Subject: 225 Broadway

I will not be able to attend the hearing on Monday for the proposed development at 225 Broadway. Please include these written comments in the docket for the hearing.

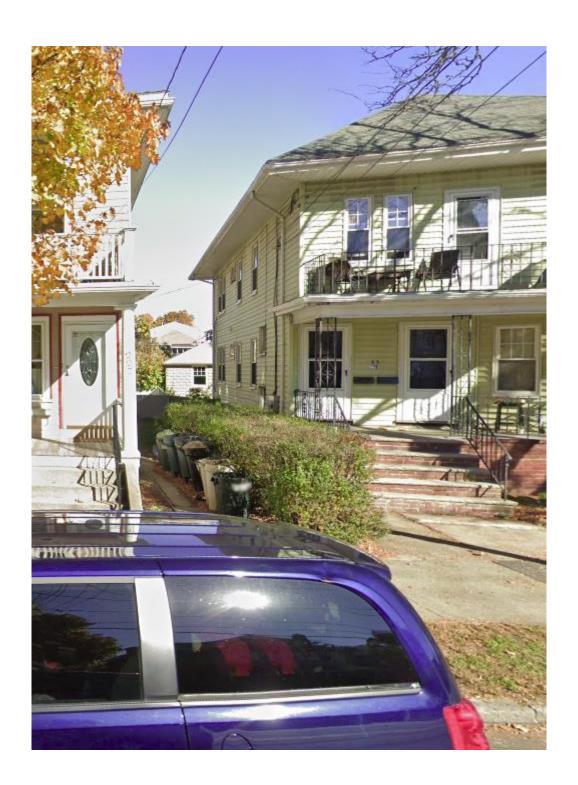
This is fortunate as it will protect the neighboring properties from inadequate 5' side yard setbacks that are being proposed. As shown in the photos below, the homes to either side of this lot are located approximately 5' from the property line. As proposed, the new development would be within about 10 feet (and closer at the roof lines) of the neighboring homes. As demonstrated by the Bowdoin St. garage fire several years ago, which was believed to have ignited a nearby home, such minimal building separations are inadequate to protect the life and property of abutters. (See photos and links to news coverage of that fire below.)

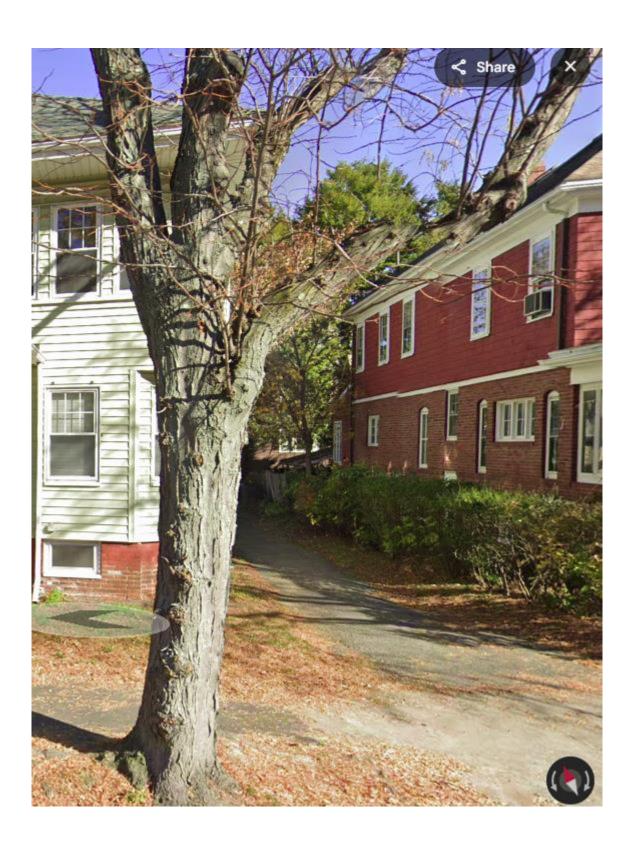
In addition to violating the minimum front yard width requirement, the proposed development also violates the the parking standards of Section 6 of the Zoning Bylaw (see below). Dimensions are not provided for the four vehicle parking spaces, but they do not appear to meet the standards of Section 6.1.11.A. The parking clearly does not meet the standard of Section 6.1.11.D (5). Backing out of this garage onto Broadway is not allowed for a four-unit building, and the proposed garage does not contain adequate space for vehicles to turn around.
